Request for Information (“RFI”)

Harrison, Town-Village Recreation Center Phase 2
270 Harrison Avenue
Harrison, NY 10528

#035

Regarding: WCHP COMPONENTS & SEQUENCE OF OPERATION

M-704

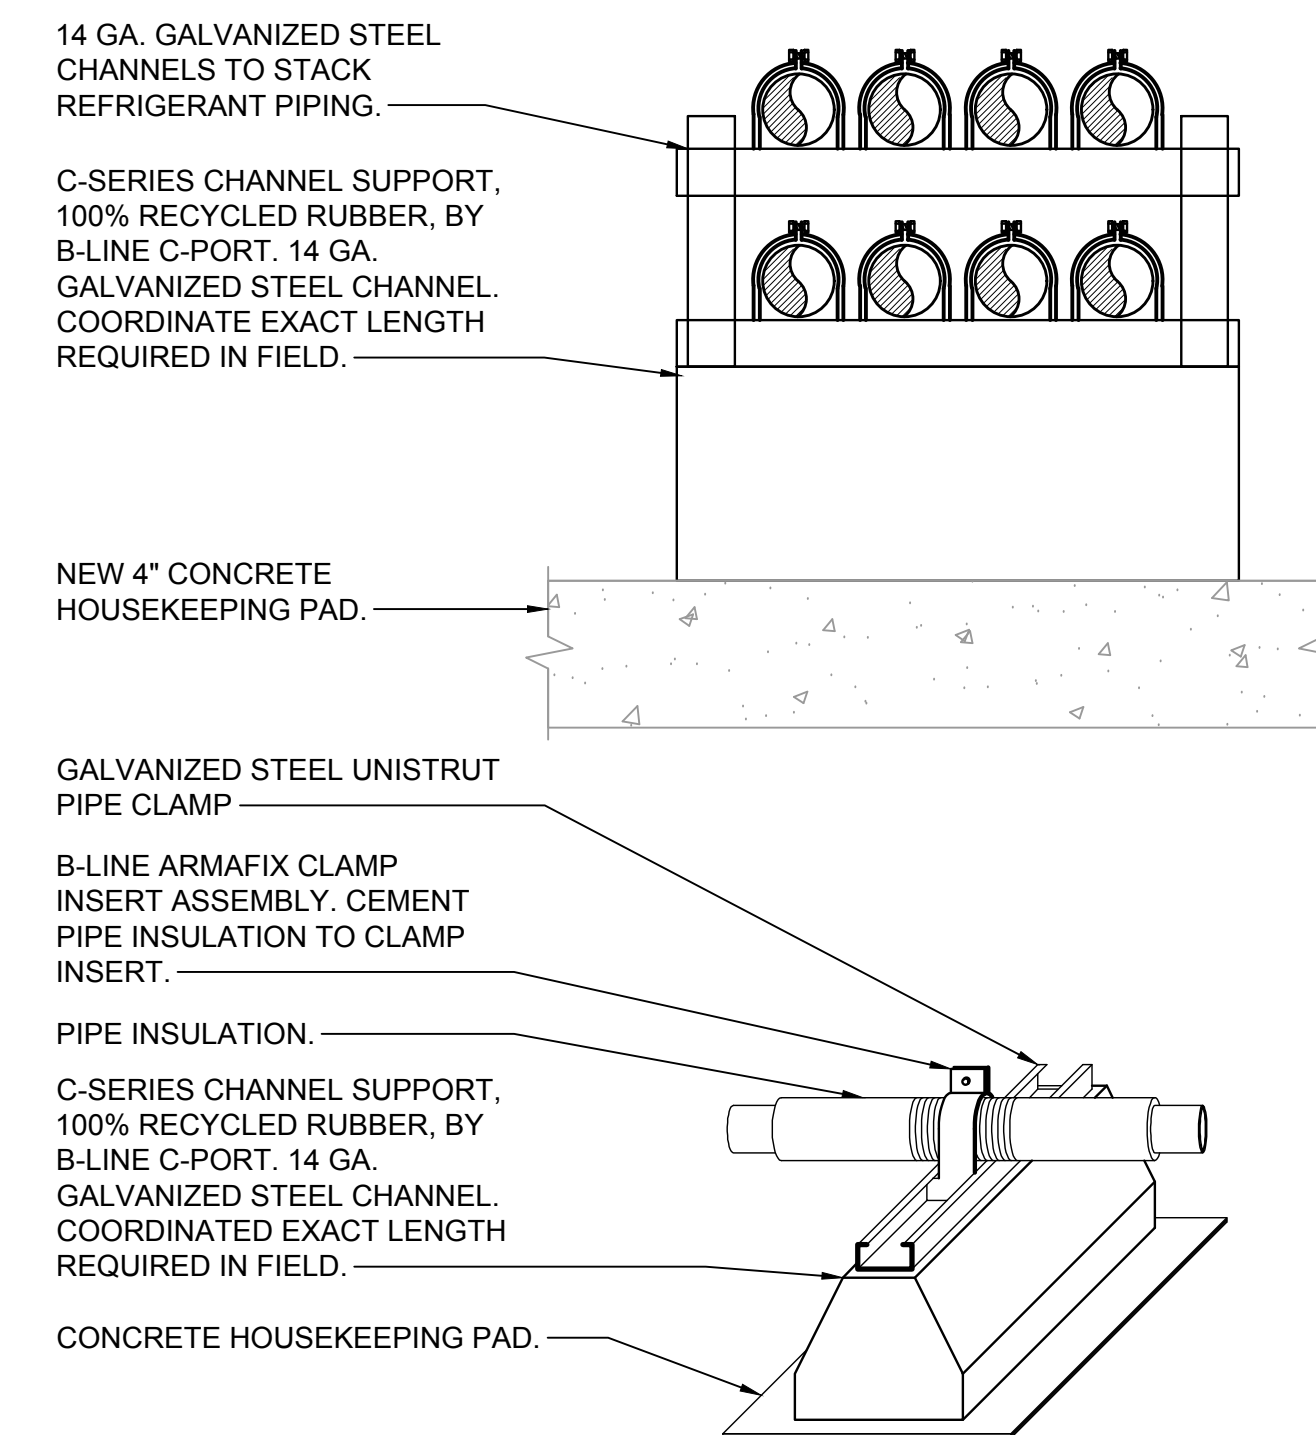
- 1 - Please provide the model numbers for the control valves and flow switch shown on M-704.
- 2 - Please provide the sequence of operation for the full system and components.

Refer to Specification 230900, Section 2.9-H for water flow switches. Refer to Specification 230900, Section 2.12 for control valves. Refer to attached sequence from LG for water source heat pumps.
